Civil Air Regulations Amendment 4b-8

Effective: May 16, 1953

AIRPLANE AIRWORTHINESS - TRANSPORT CATEGORIES

FIGURE 4b-23 - BASIC FLIGHT INSTRUMENT PANEL ARRANGEMENT

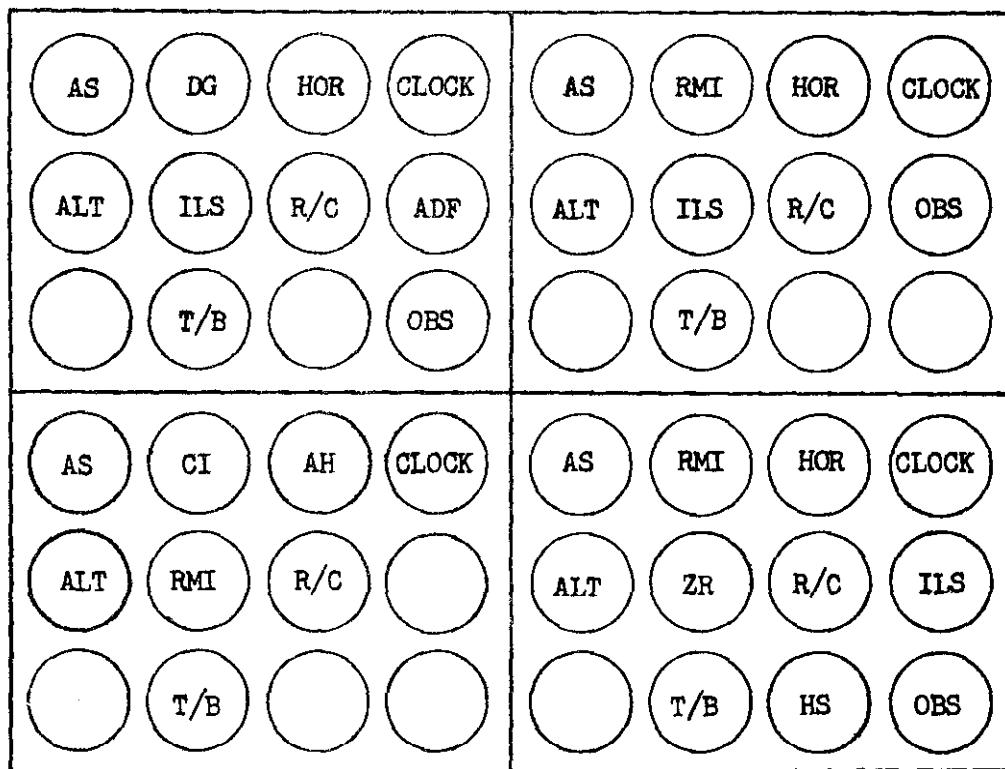
Sections 4b.353, 4b.358, 4b.471, 4b.473, 4b.474, 4b.476, 4b.604, and 4b.611 and Figures 4b-16, 4b-17, and 4b-23 are amended to change the present provisions concerning cockpit standardization. These changes bring the present provisions into general conformity with the standards adopted by the Munitions Board and the Society of Automotive Engineers.

46. By amending Figure 4b-23 to read as follows:

(b) Flight instruments required by § 4b.603 shall be grouped in accordance with one of the flight instrument panels in Figure 4b-23 dependent upon which instruments are installed. The panel shall be centered as nearly as practicable about the vertical plane of the pilot's forward vision. The required flight instruments not shown in Figure 4b-23 shall be placed adjacent to the prescribed grouping.
